[REDACTED]
St. Louis (St. Louis Co.), MO 63110

Location ID: MO55
N 38° 37' 22.44"
W 90° 14' 20.93"
713 feet (estimated)¹

GENERAL AREA DESCRIPTION

HELIPORT/HELIPAD DESCRIPTION

Figure 3: Obstructions Outside the Safety Area

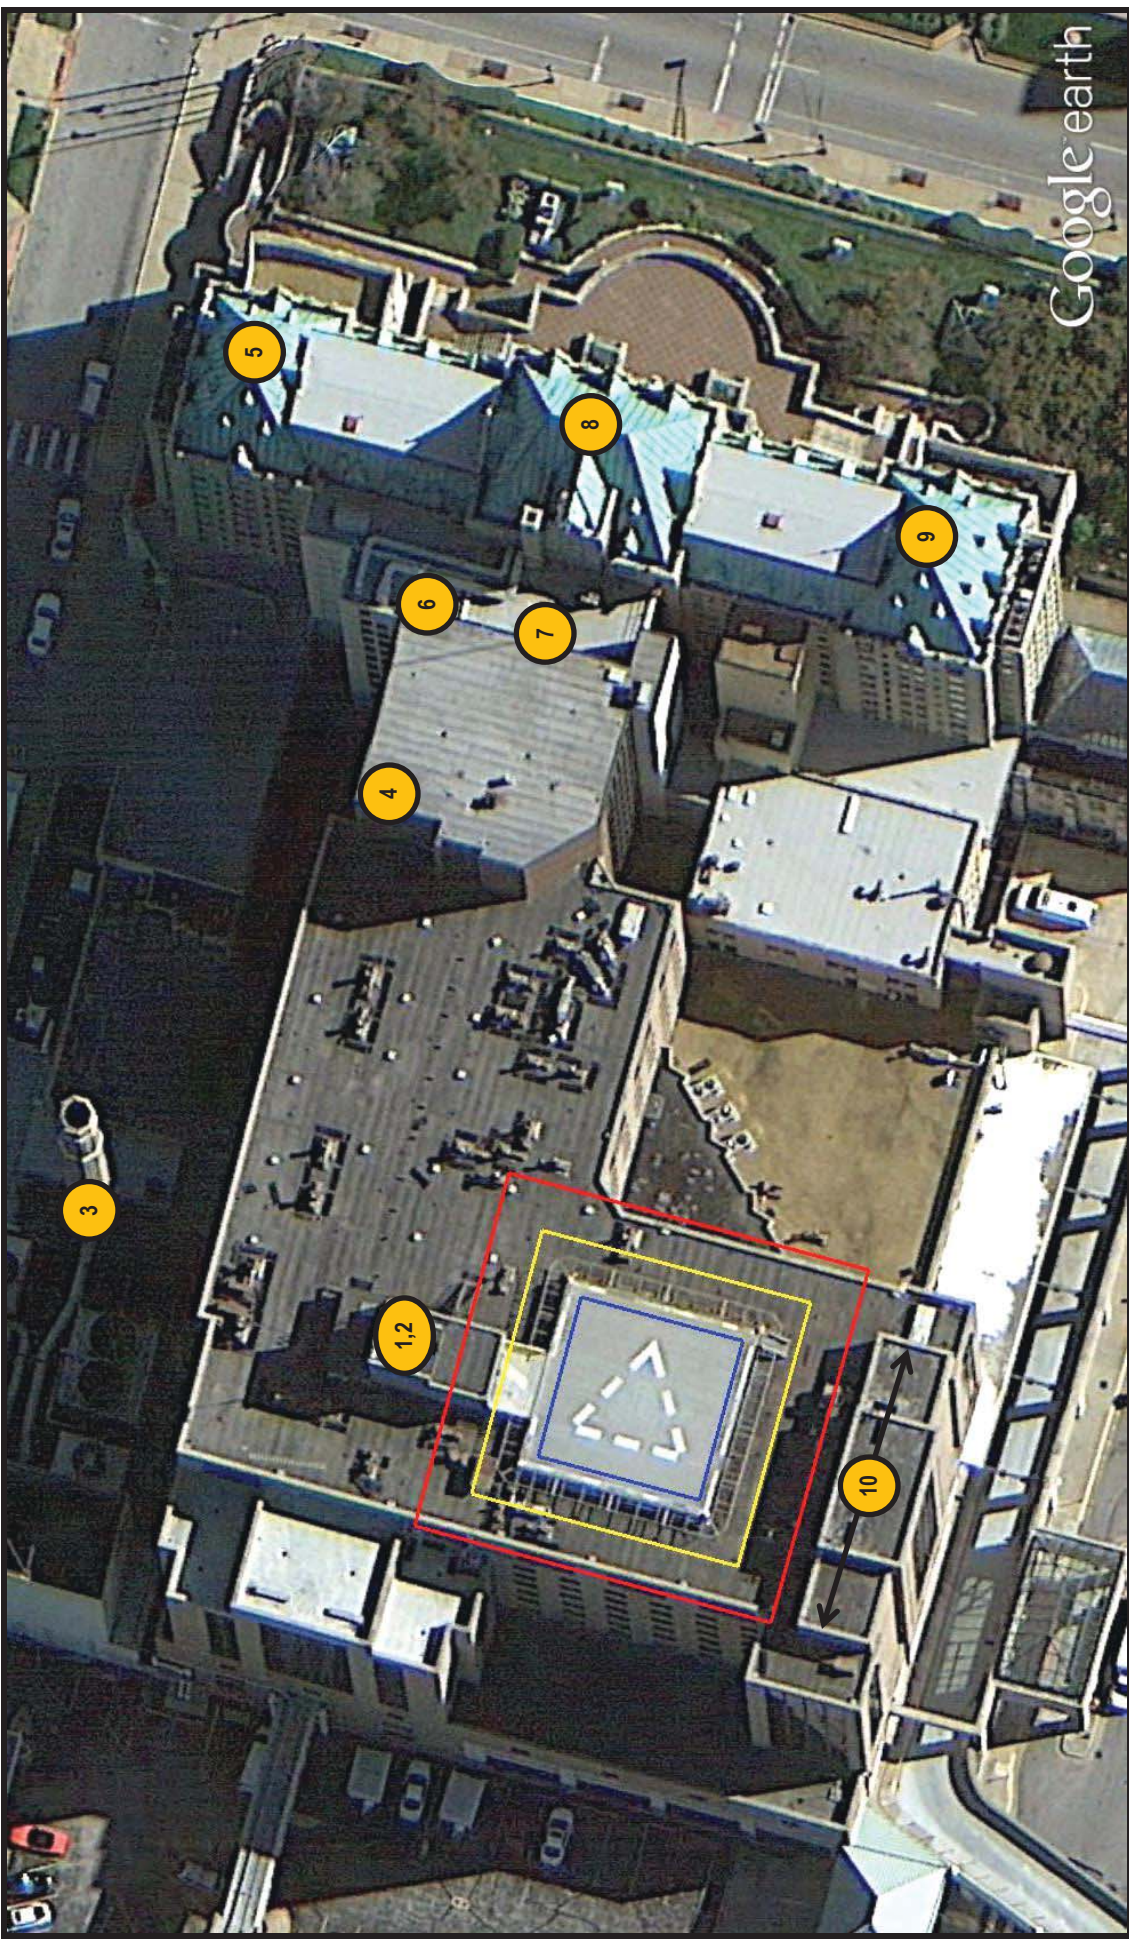
NO.	OBSTRUCTION TYPE	AZIMUTH FROM TLOF CENTER (TRUE NORTH) ²	HEIGHT ABOVE TLOF ELEV	DISTANCE FROM FATO	MAXIMUM PENETRATION
1	Elevator Shaft	005°–020°	25'	17'	22.8'
2	Wind Cone	011°	40'	33'	35.9'
3	Smoke Stack	018°	54'	106'	40.8'
4	Building	064°–094°	33'	84'	22.5'
5	Church Spire	069°	65'	230'	36.3'
6	Antenna	075°	70'	161'	49.9'
7	Antenna	083°	105'	149'	86.4'
8	Church Spire	087°	≅ 75'	246'	44.3'
9	Church Spire	108°	65'	224'	37.0'
10	Building	164°–236°	7'–14'	19'	11.7'

¹ Except where otherwise noted, all obstructions listed in Table 1 penetrate the obstruction-free approach/departure surface ratio of 8:1 (7.125°).

Figure 4: Obstructions Inside the Safety Area

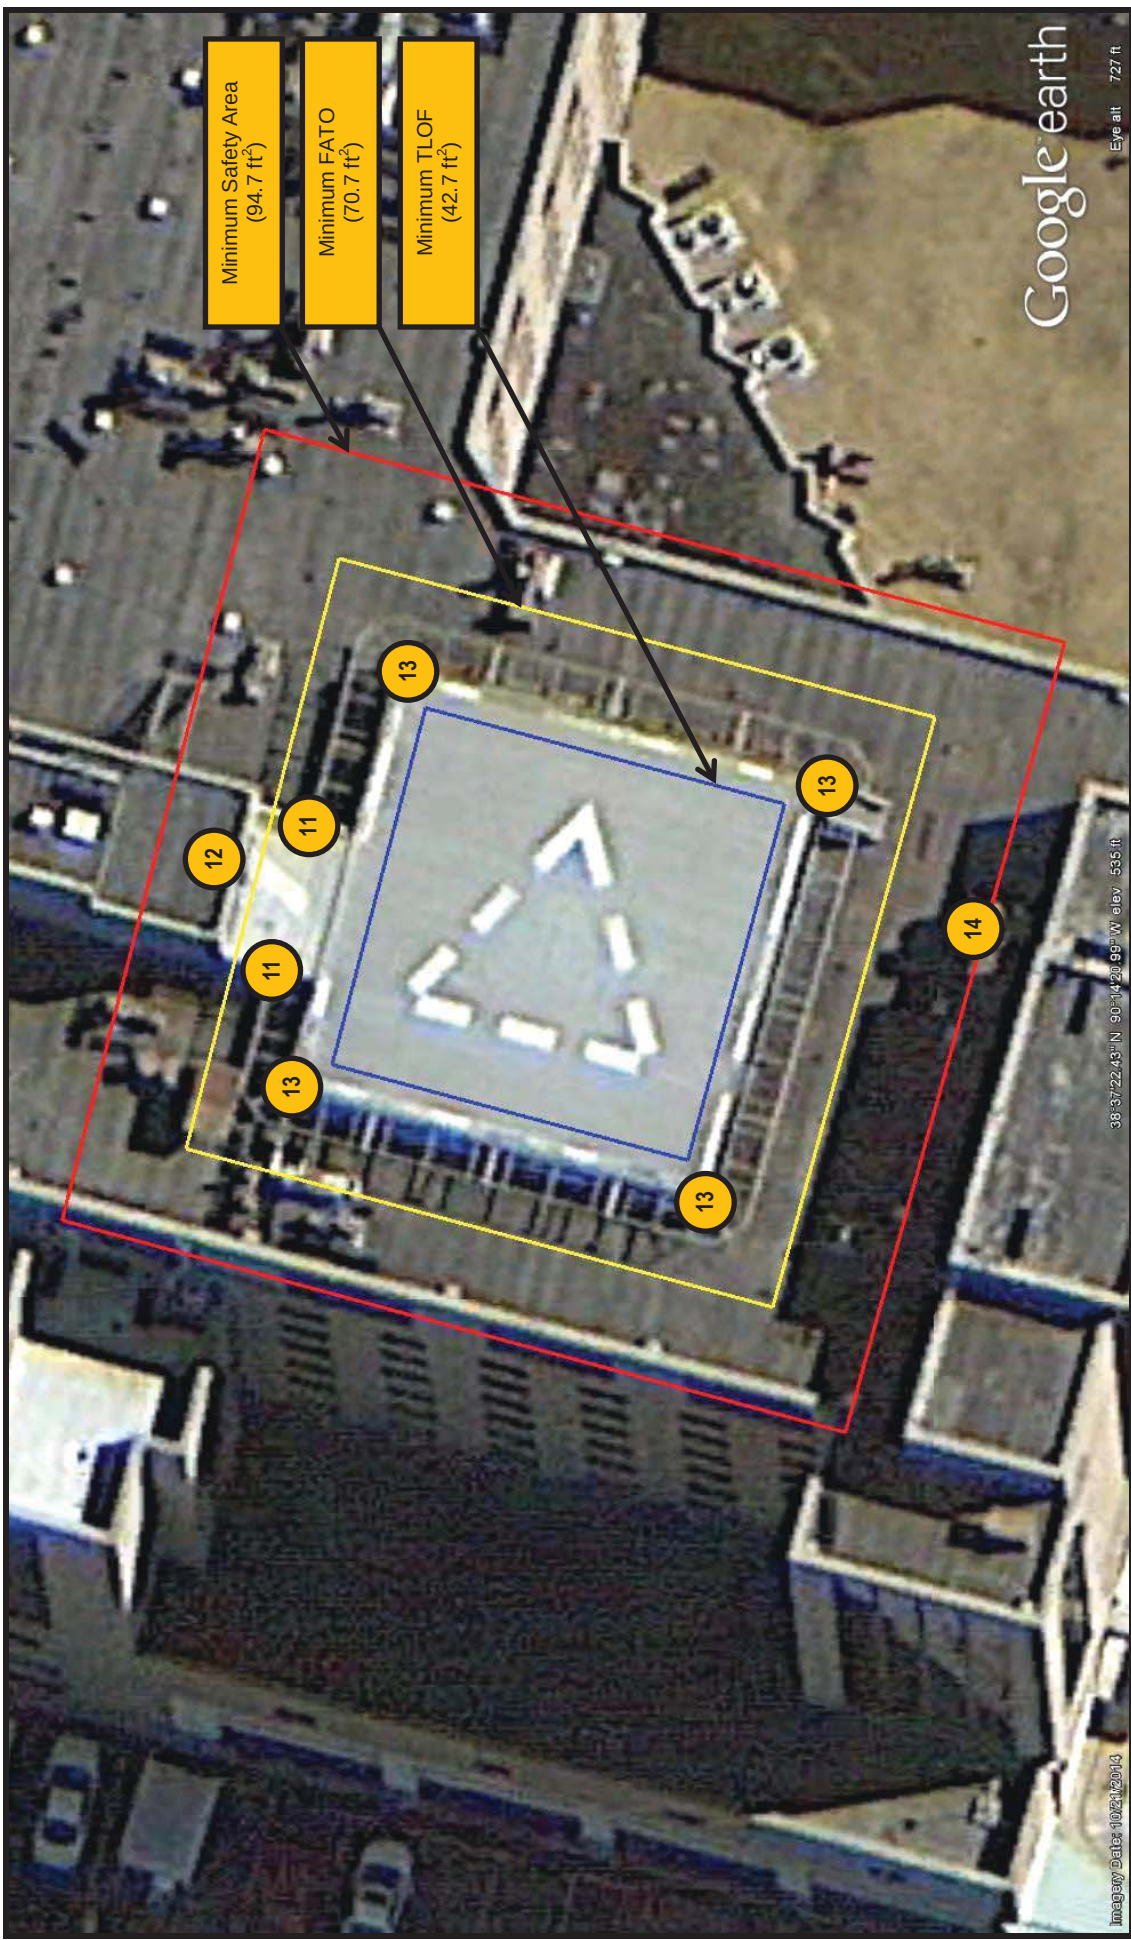
NO.	OBSTRUCTION TYPE	AZIMUTH FROM TLOF CENTER	HEIGHT ABOVE TLOF ELEV ³	DISTANCE FROM TLOF CENTER	EXCEEDS MAX HEIGHT BY
11	Hand Rail (2)	351° & 026°	3.5'	29' & 27'	3.2'
12	Elevator Shaft Foyer	357°–024°	≅ 11.0'	37'	10.8'
13	Raised Flood/Perimeter Lights (4)	All Quads	1.5'	35'	1.3'
14	Building Ventilation Equipment	178°	5.0'	47'	4.8'

³ Unless otherwise noted, objects listed in Table 2 exceed the maximum recommended height above FATO elevation of 2 inches (AC 150/5390–2C, Pars. 407[e] & 408[c]).

1. The final approach and takeoff area (FATO) and its associated safety area contain obstructions which significantly exceed the maximum height recommended for objects within this area: Notably, the structures and ductwork associated with the building ventilation systems, 4 raised perimeter/flood lights, an adjacent structure that houses an elevator shaft, and 2 handrails that extend from the entrance of the elevator shaft to the edge of the touchdown and liftoff area (TLOF).

Figure 20: TLOF Perimeter Marking; Safety Net

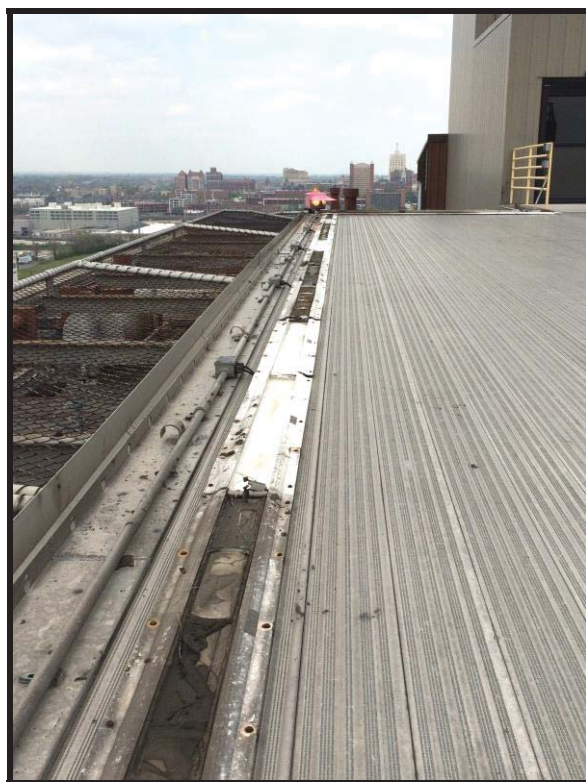
1. The heliport is not marked in accordance with the recommendations of AC 150/5390–2C, Par. 414, and associated figures.
2. The heliport is not lighted in accordance with the recommendations of AC 150/5390–2C, Par. 415(a)(2).
